# 1013 NE 45TH STREET

SDCI # 3037927-EG | MUP # 3037792-LU

RECOMMENDATION MEETING

03.28.2022

## 4. MATERIALS

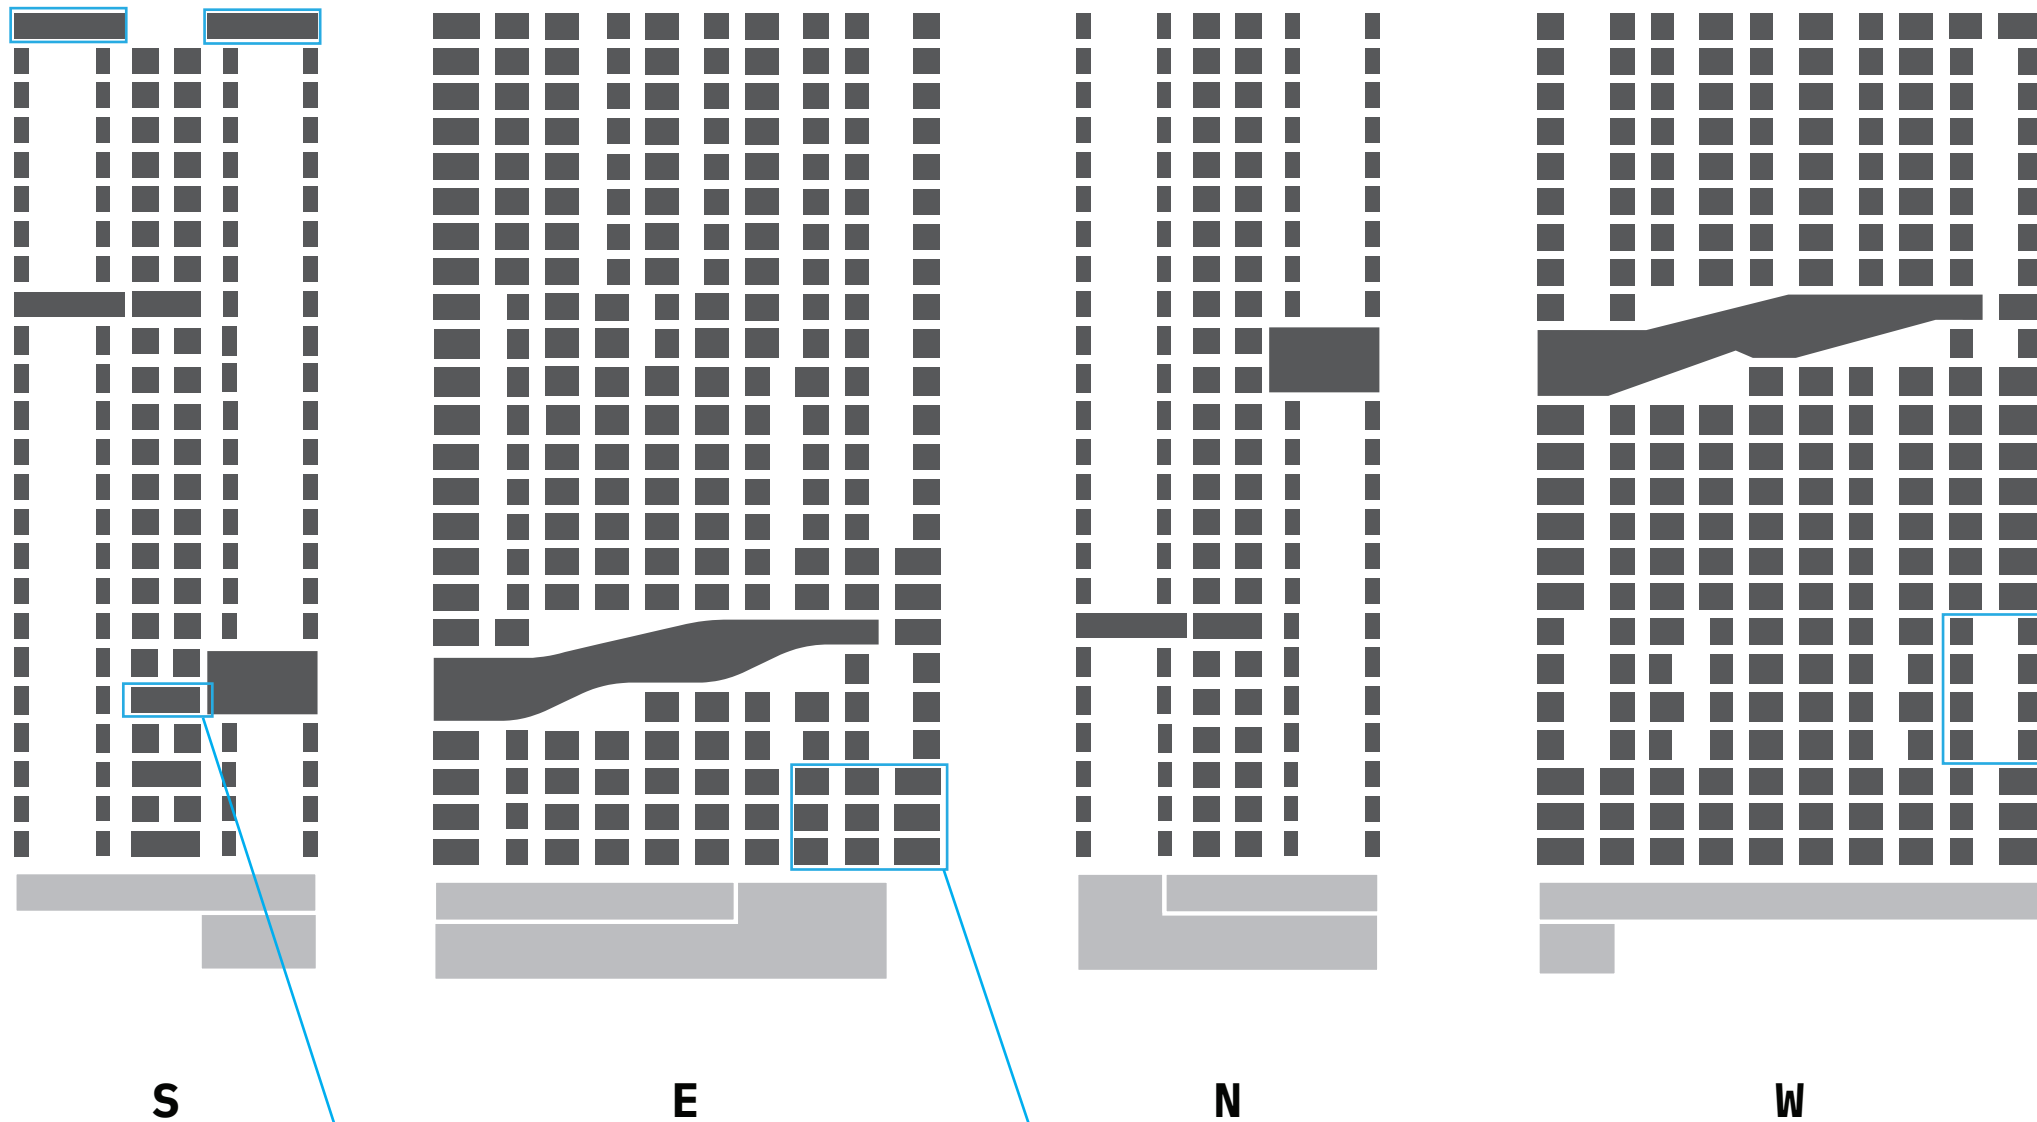
*The Board indicated support for the very preliminary façade concept, utilizing a rigorous pattern contrasting the more whimsical carved space from the façade planes and agreed that should be carried through to a cladding expression that contrasts the solid and void. (DC4-A Exterior Elements and Finishes)*

### DESIGN RESPONSE

#### 4. MATERIALS

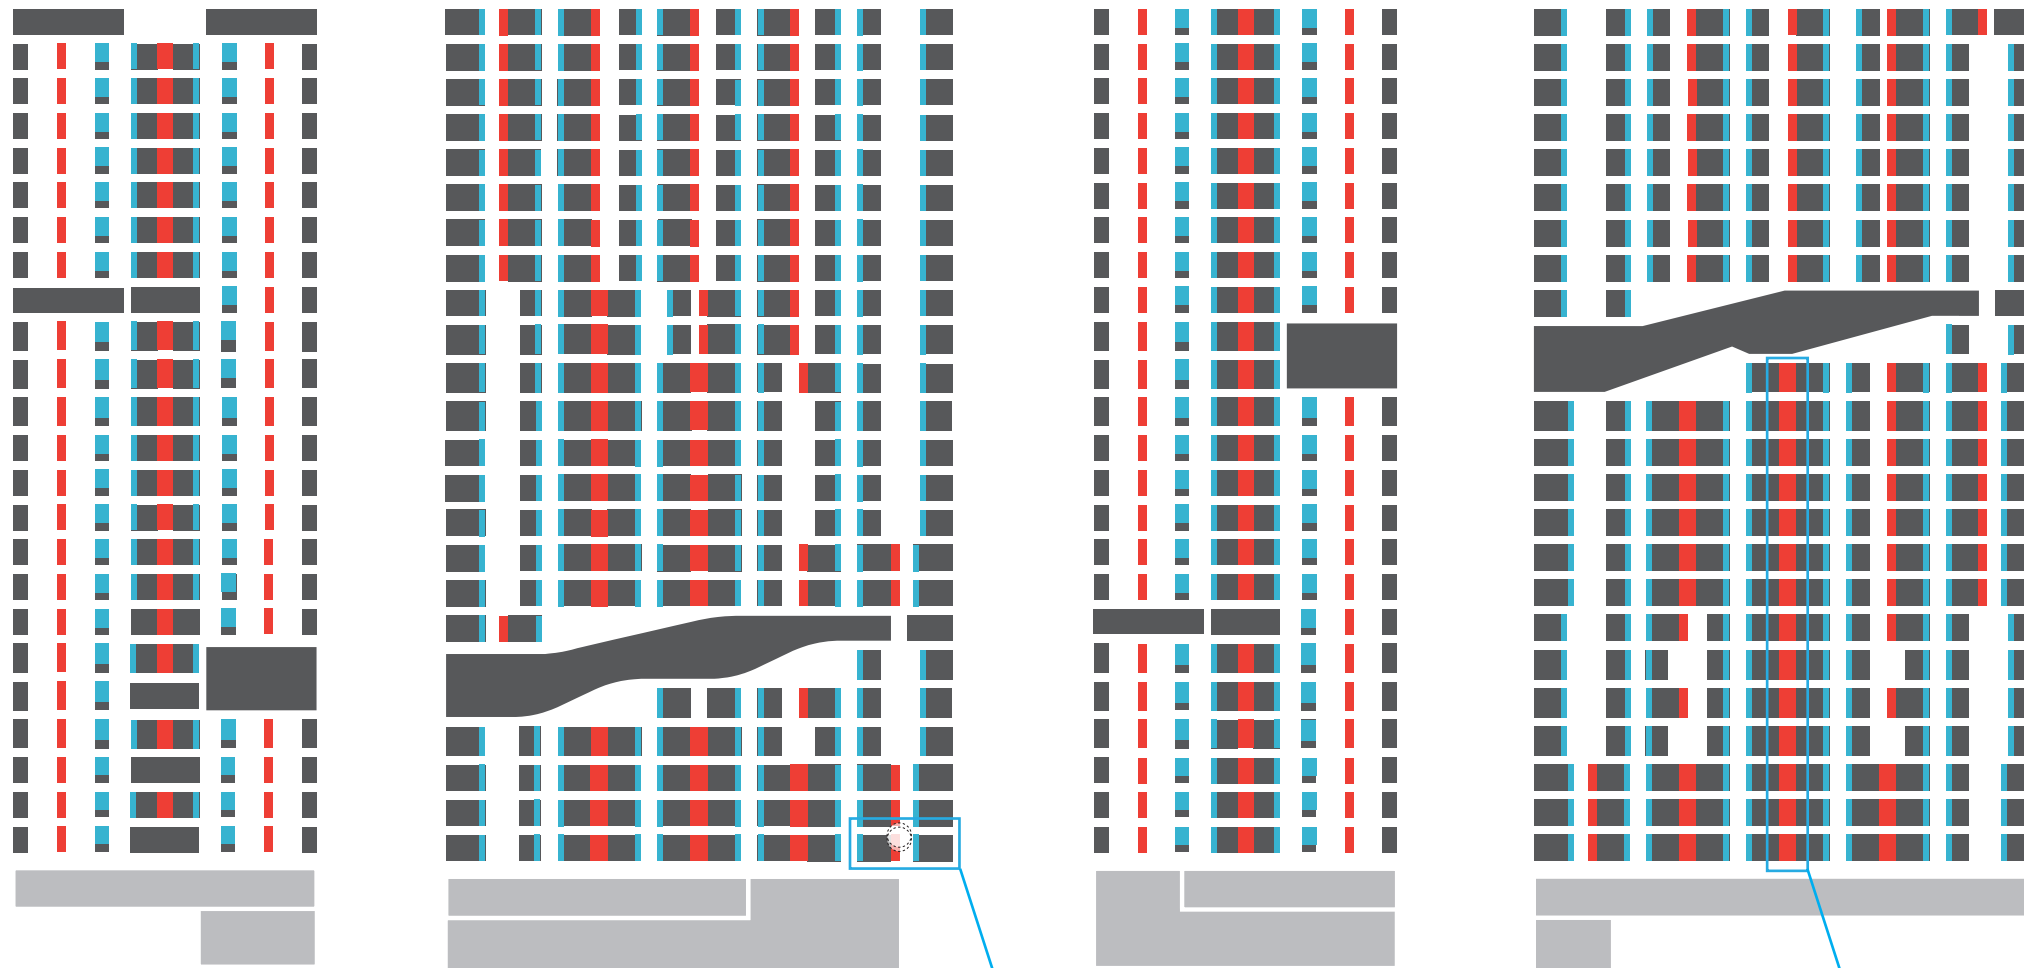
**DESIGN REVIEW BOARD DIRECTION:**  
*The Board indicated support for the very preliminary façade concept, utilizing a rigorous pattern contrasting the more whimsical carved space from the façade planes and agreed that should be carried through to a cladding expression that contrasts the solid and void. (DC4-A Exterior Elements and Finishes)*

**DESIGN RESPONSE**  
 + The digram on the left shows vision glass optimization. To meet Washington State Energy Code there will be a limitation of glazing. A typical design target is 40% vision glass +/- . By increasing glazed areas in public space and reducing it in private areas such as bedrooms, variety in the facade grid can be expressed.
